Project: Chehalis Basin Strategy

Subject: WA Ecology: Information from FCZD Related to SEPA Final EIS, 5. Fish Passage Design – Response to Requested Information

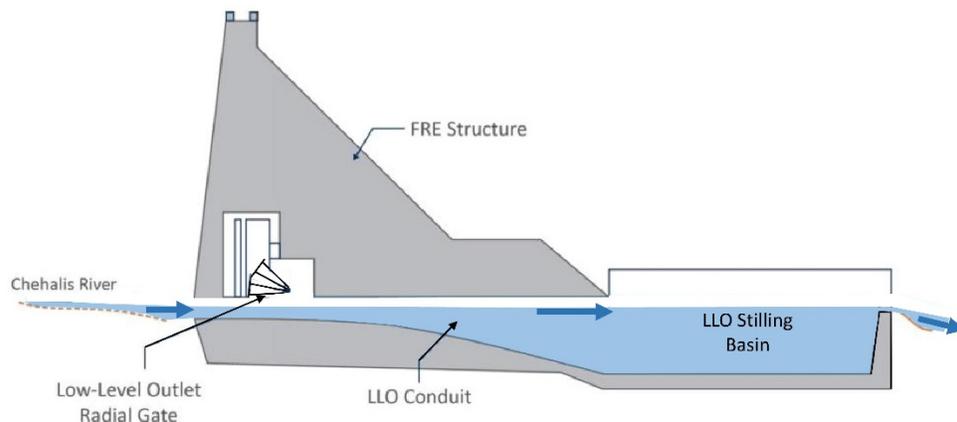
- **Clarify if a weir is included that submerges the outlets and its location relative to the CHTR entrances.**
 - The downstream end of the stilling basin, also referred to as the endsill, acts as a submerged weir but does not submerge the conduit outlets. The conduits are not surcharged, and the entrance of each conduit is not submerged during normal fish passage flows (16 cfs – 2,200 cfs). The conduits can pass up to 12,500 cfs, or just under a 10-year flood event, in an open channel flow condition (Section 5.6 of the FRE Report; [Table 4-1 of the 2017 Combined Dam and Fish Passage Conceptual Design Report](#) [Combined Report]).

- The endsill of the stilling basin is located roughly 230 feet downstream of the conduit outlets. The endsill has a crest elevation of EL 417.0. (See FRE-S-7 of the FRE Report). The invert of the 12' W x 20' H conduit is at EL 408. The inverts of the 10' W x 16' H conduits are at EL 411. (See Section 5.6 of the FRE Report). As shown in Figure 2-23 of Appendix I of the FRE Report, the water surface elevation over the endsill at the maximum fish passage flow (2,200 cfs) is just under WSEL 422. This corresponds to conduits about 70% full.

- The relative elevation of the bottom of the river channel in relation to the endsill crest elevation and stilling basin floor is shown in Section C-C of Figure 5-2 of the FRE Report. The design intent is that there will not be a hydraulic drop from the stilling basin endsill to the river channel downstream, as depicted in the figure of the conduit section provided to Ecology in January/February 2020 (reproduced below).
